Rec'd 9.3.2014  
in Pl. Div.

ANDERSON ST REALTY  
 322 FORE ST. PORTLAND, MAINE  
**122 ANDERSON STREET**  
 PORTLAND MAINE

**C1.3**

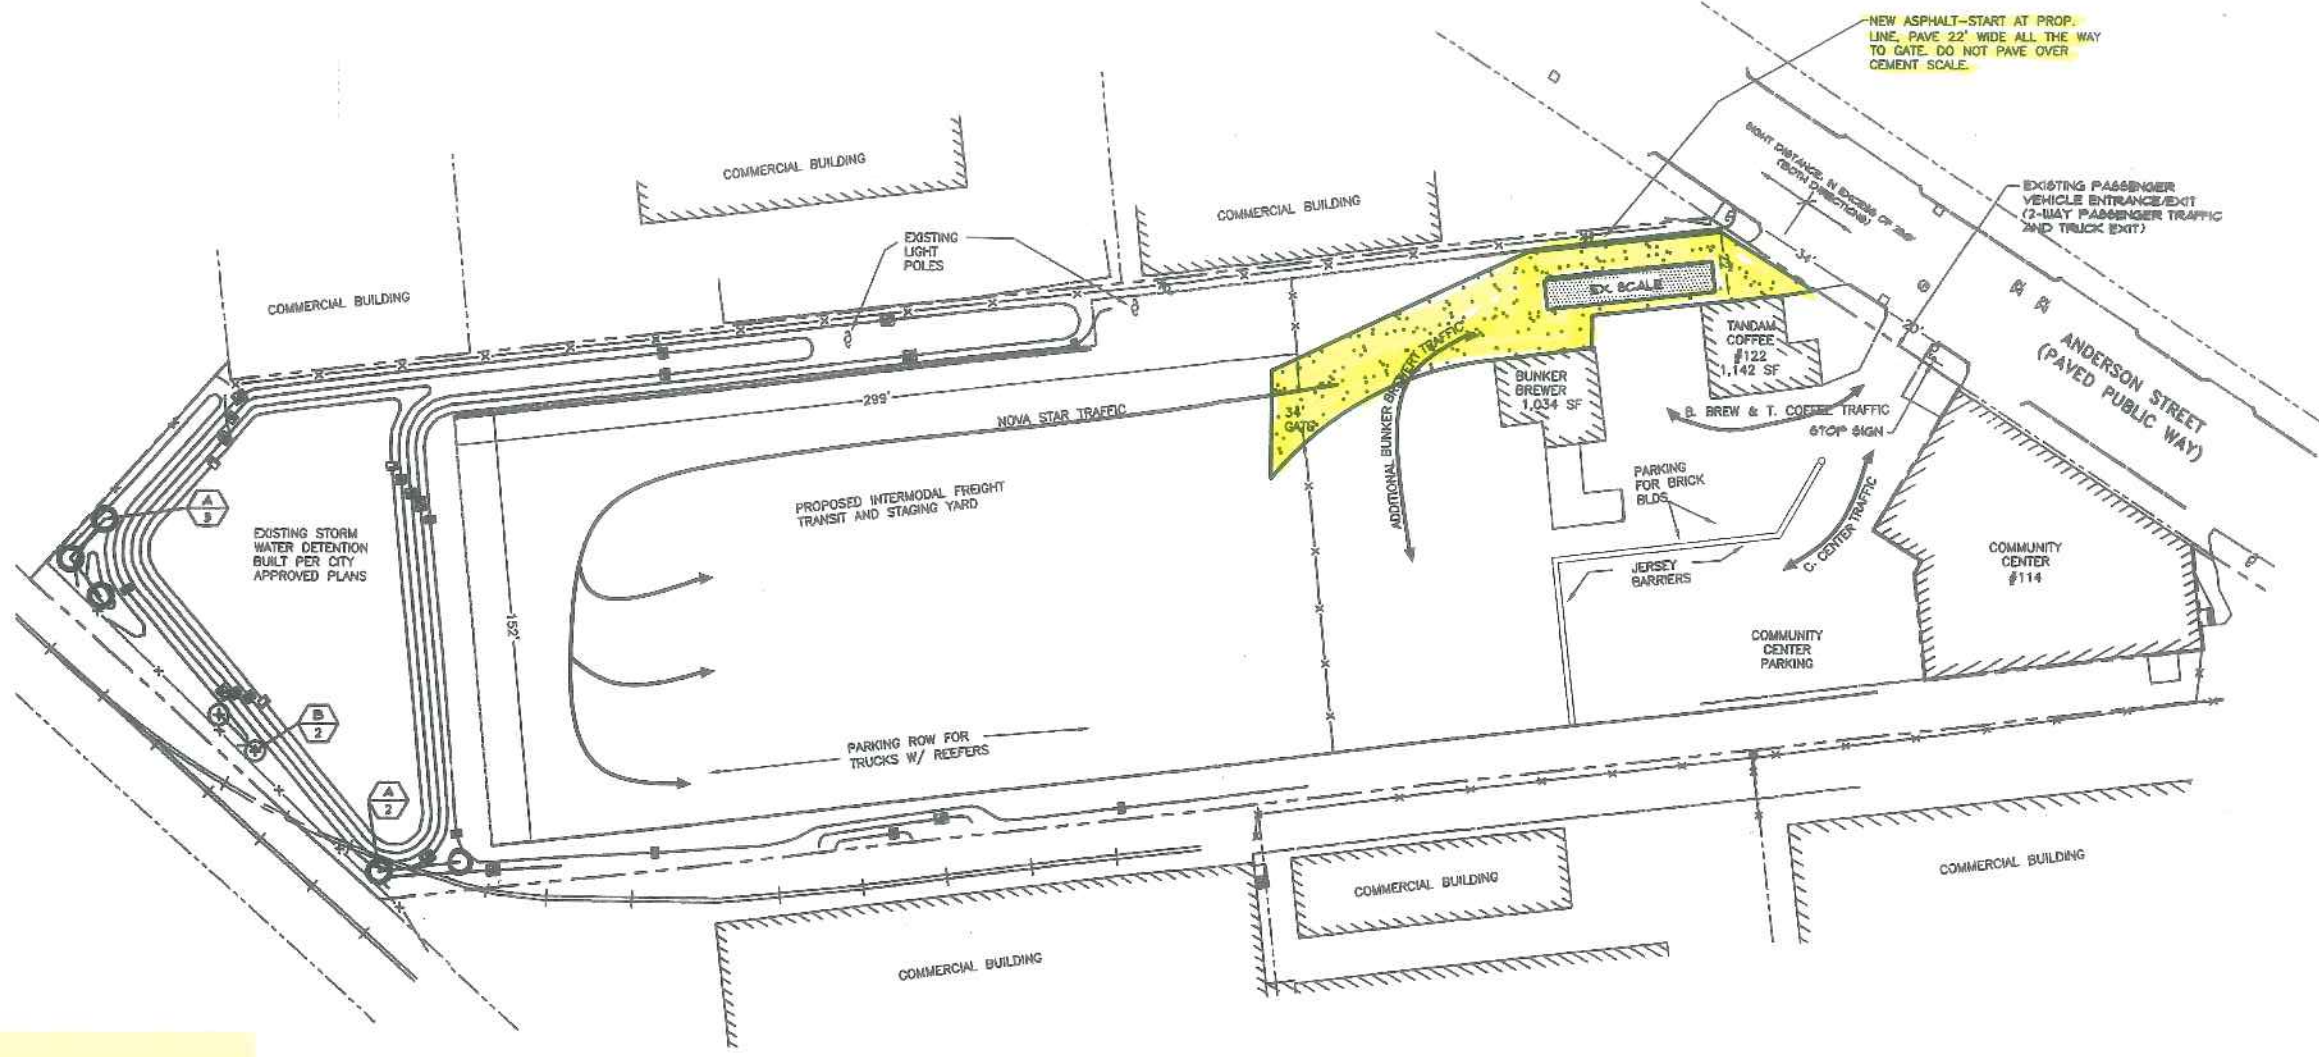
Hi Jean,  
 ① These are the paving plans for your approval!  
 ② Need to know how many "Truck entering signs" & where to get the right ones  
 ③ I will ask Zebra striping to paint the cross walks but we need guidance?
